Chris Smith
Principal Planner
London Borough of Camden
Planning and Borough Development
5 Pancras Square
c/o Judd Street
London
WC1H 9JE

RE: Formal Objection to the Redevelopment of Tavis House, Planning Reference 2024/1267/P

^{1.1. &}lt;sup>7</sup> Verified View 2 Jon Lowe Heritage Townscape Impact Assessment

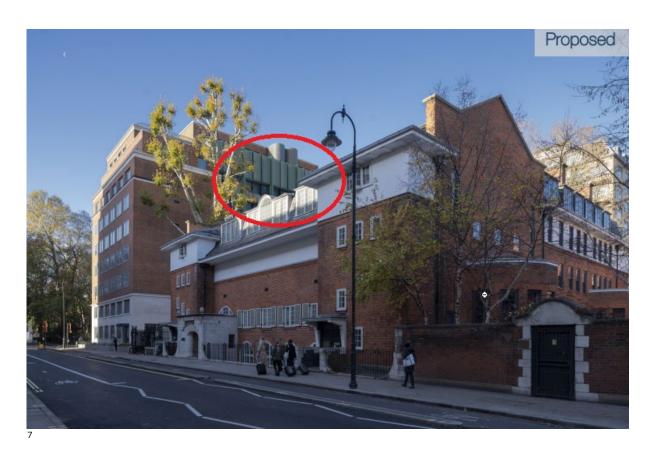
18.1. The principle of development concerning the rear of the site and return alterations necessitates thorough consideration, particularly in its potential impact on the setting of Mary Ward House and the surrounding Conservation Area. While there is acknowledgment that improvements are needed to enhance the overall setting, it is vehemently disputed that the proposed development at the rear is acceptable.

- 18.2. The Listed Gates Railings and Piers are due to be restored and will be visually less discernible against to current proposed backdrop.
- 18.3. Jon Lowe Heritage Townscape Impact Assessment seeks to argue that "the gap between Tavis House and Mary Ward House is clearly defined, and it acts as an important 'break' between the varied townscapes of Tavistock Place and Tavistock Square." It is obvious from the below photographs, which are reproduced from the Townscape Impact Assessment, that no such clear gap exists.
